ATTACHMENT 3

TECHNICAL SPECIFICATION CHANGES

TECHNICAL SPECIFICATION

TITLE: UNIT 1 CORE OPERATING LIMITS REPORT  
CYCLE 2 (RELOAD 1)  
\_\_\_\_\_

FIGURE 3.2.1-1

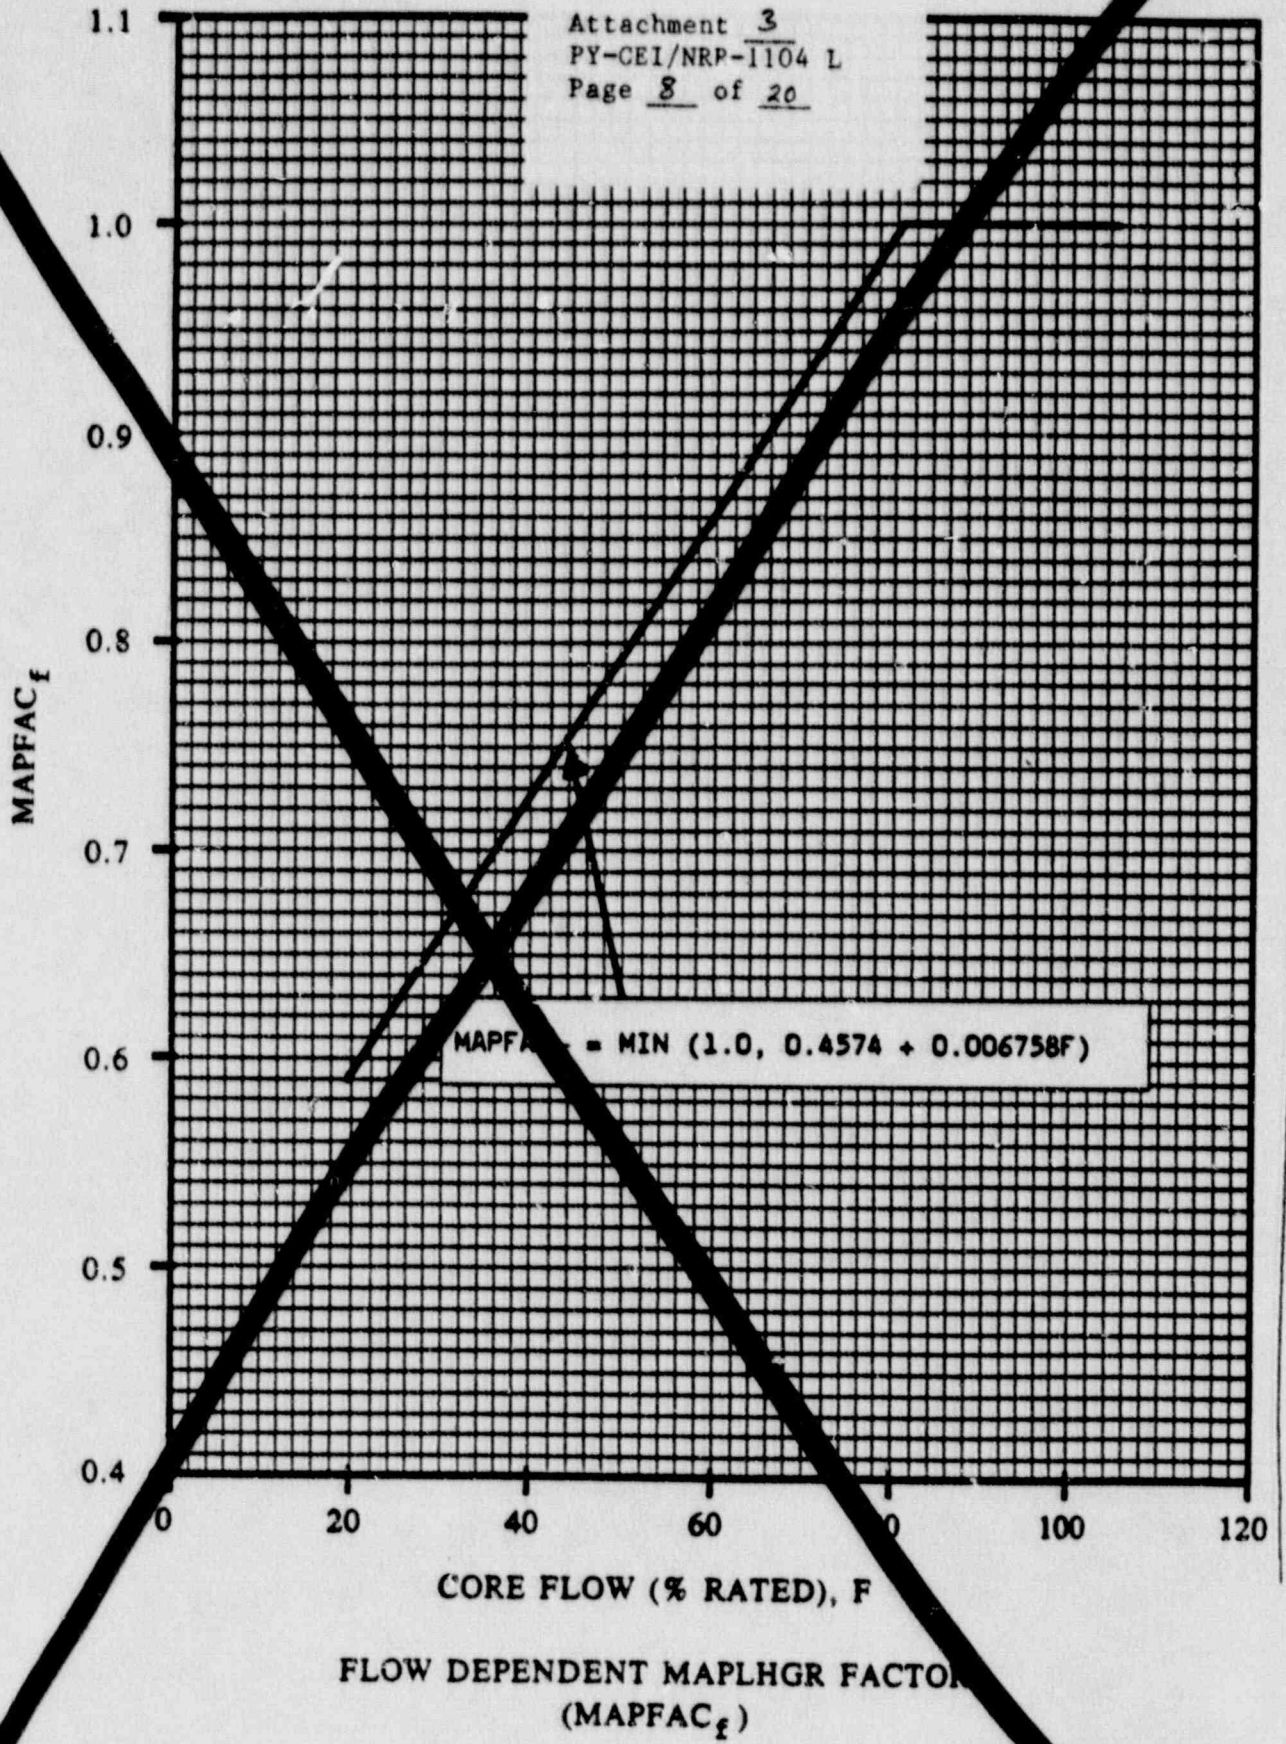
3.2.1 All AVERAGE PLANAR LINEAR HEAT GENERATION RATES (APLHGRs) shall not exceed the result obtained from multiplying the applicable MAPLHGR values\* by the smaller of either the flow dependent MAPLHGR factor (MAPFAC<sub>f</sub>) of Figure 3.2.1-1 or the power dependent MAPLHGR factor (MAPFAC<sub>p</sub>) of Figure 3.2.1-2 *limits specified in the CORE OPERATING LIMITS REPORT.*

*limits specified in the CORE OPERATING LIMITS REPORT,*  
If at any time during operation it is determined that an APLHGR is exceeding the result of the above multiplication, initiate corrective action within 15 minutes and restore APLHGR to within the required limits within 2 hours or reduce THERMAL POWER to less than 25% of RATED THERMAL POWER within the next 4 hours.

Figure 3.2.1-3

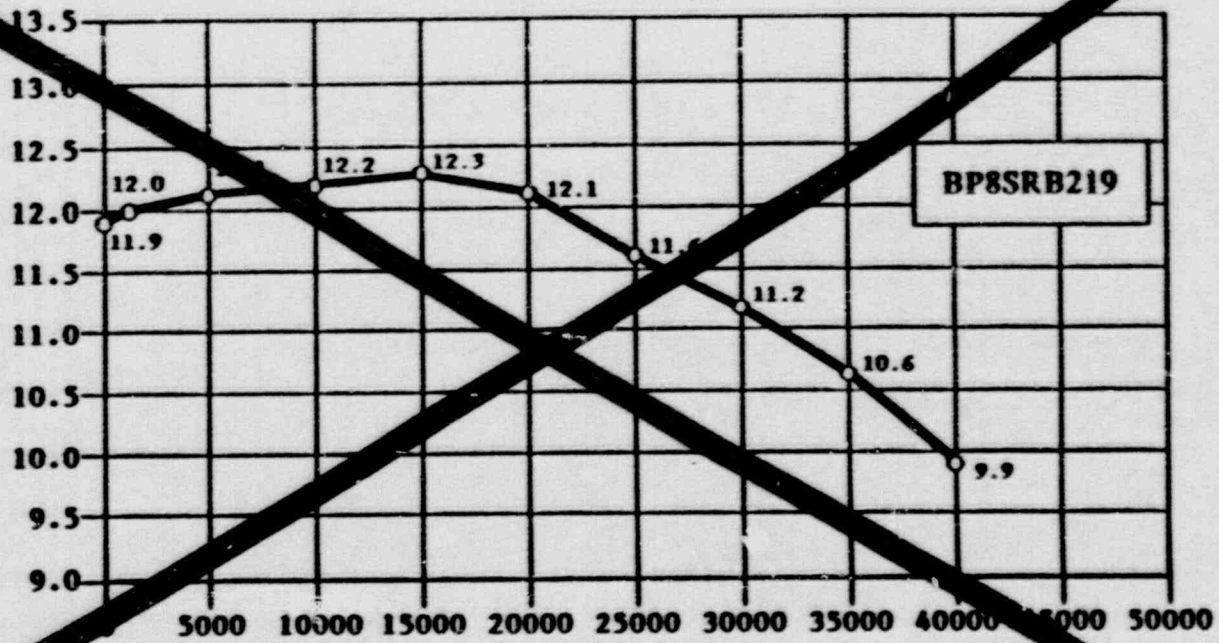
Figure 3.2.1-4	Maximum Average Planar Linear Heat Generation Rate (MAPLHGR) Versus Average Planar Exposure Initial Core Fuel Types BP8 SRB 176.....	3/4 2-5	2 <u>Delete</u>
Figure 3.2.1-5	Maximum Average Planar Linear Heat Generation Rate (MAPLHGR) Versus Average Planar Exposure Reload Core Fuel Types BS301E.....	3/4 2-6	
Figure 3.2.1-6	Maximum Average Planar Linear Heat Generation Rate (MAPLHGR) Versus Average Planar Exposure Reload Core Fuel Types BS301F.....	3/4 2-6a	
3/4.2.2	MINIMUM CRITICAL POWER RATIO.....	3/4 2- <del>X</del> 2	2 <u>Delete</u>
Figure 3.2.2-1	MCP <sub>Rf</sub> .....	3/4 2-8	
Figure 3.2.2-2	MCP <sub>Rp</sub> .....	3/4 2-9	
3/4.2.3	LINEAR HEAT GENERATION RATE.....	3/4 2- <del>X</del> 3

- 1) Those that have been approved for the respective fuel and lattice type as a function of the average planar exposure (as determined by the NRC approved methodology described in GESTAR-II)  
or
- 2) When hand calculations are required, the MAPLHGR as a function of the average planar exposure for the most limiting lattice (excluding natural uranium) shown in the Figures 3.2.1-3, 3.2.1-4, 3.2.1-5, and 3.2.1-6 for the applicable type of fuel.

FIGURE 3.2.2-1

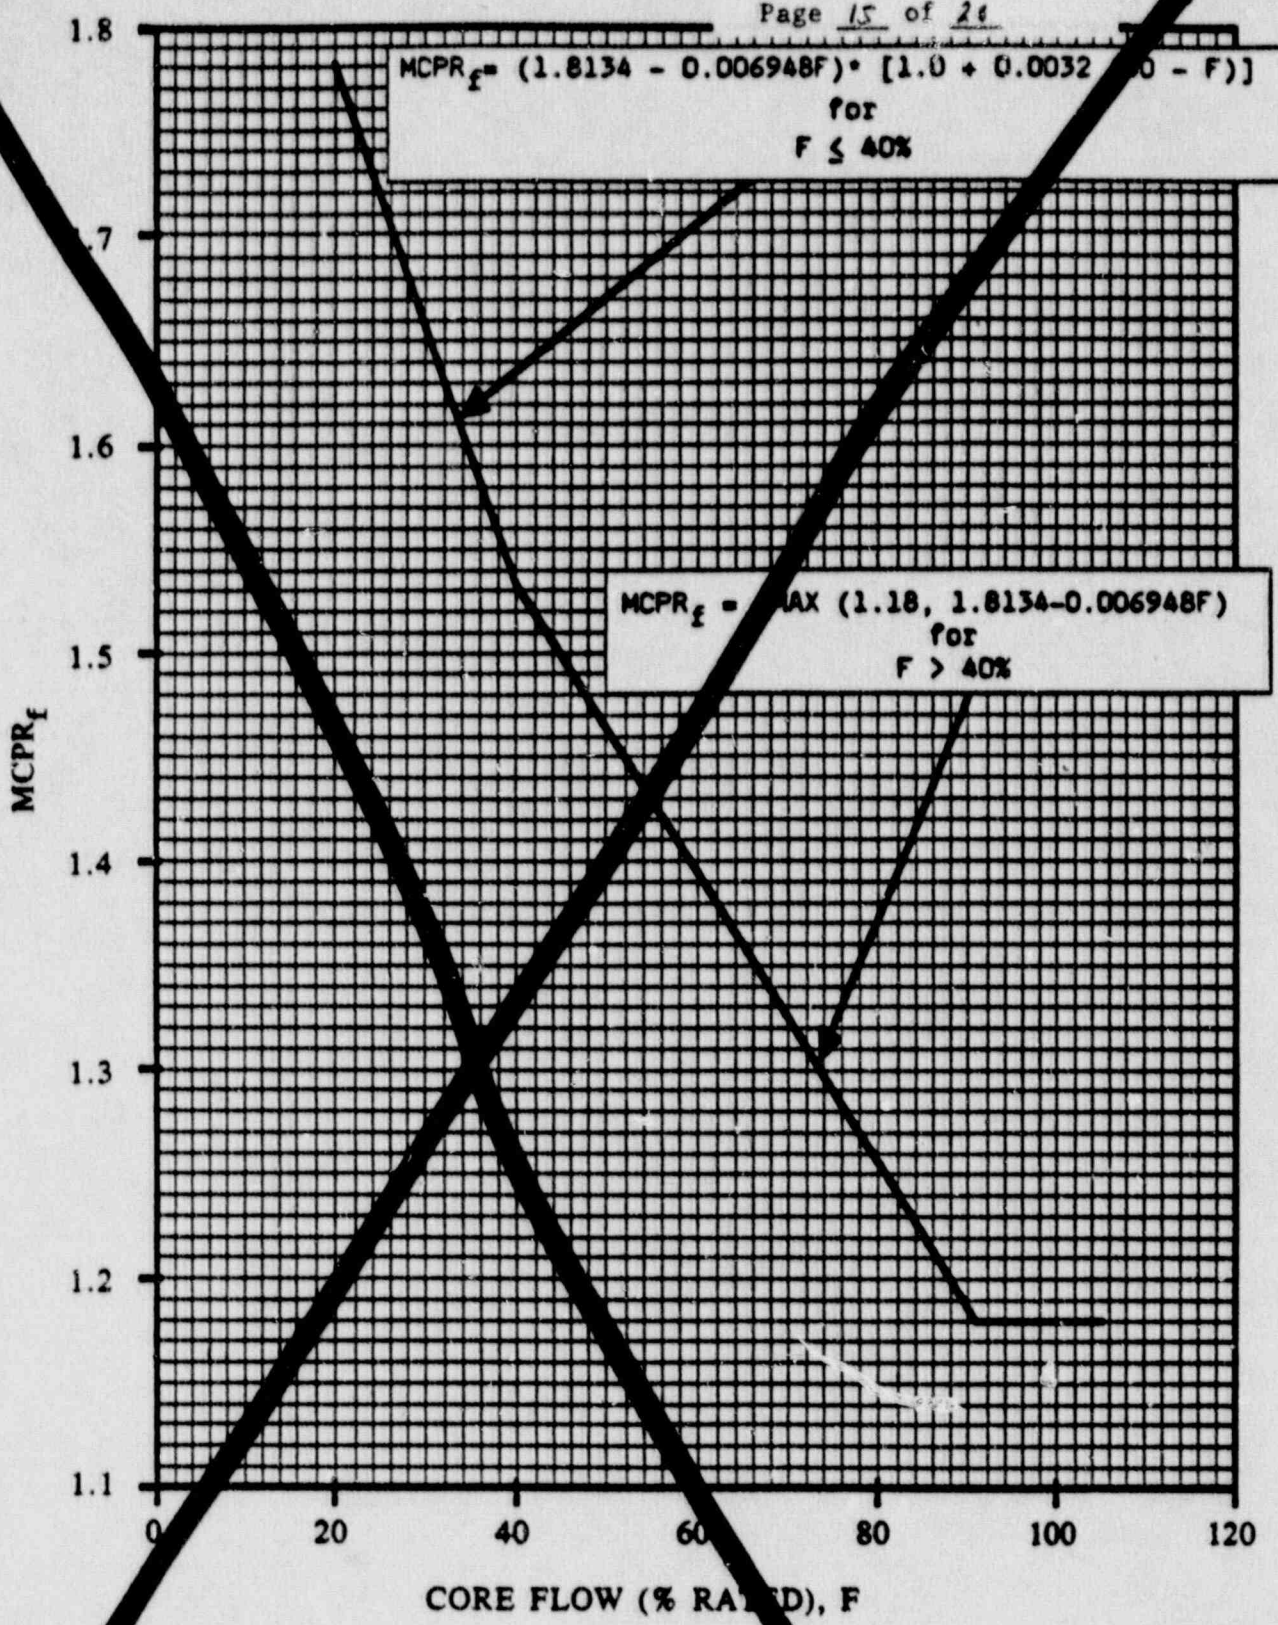
3.2.2 The MINIMUM CRITICAL POWER RATIO (MCPR) shall be equal to or greater than both MCPR<sub>1</sub> and MCPR<sub>2</sub> limits at indicated core flow, THERMAL POWER,  $\Delta T^*$  and core average exposure compared to End of Cycle Exposure (EOCE)\*\* as shown in Figures 3.2.2-1 and 3.2.2-2.

limits specified in the CORE OPERATING LIMITS REPORT, with MCPR less than the applicable MCPR limit shown in Figures 3.2.2-1 and 3.2.2-2, initiate corrective action within 15 minutes and restore MCPR to within the required limit within 2 hours or reduce THERMAL POWER to less than 25% of RATED THERMAL POWER within the next 4 hours.

4.2.2 MCPR shall be determined to be equal to or greater than the MCPR limit<sup>S</sup> determined from Figures 3.2.2-1 and 3.2.2-2:

specified in the CORE  
OPERATING LIMITS REPORT:
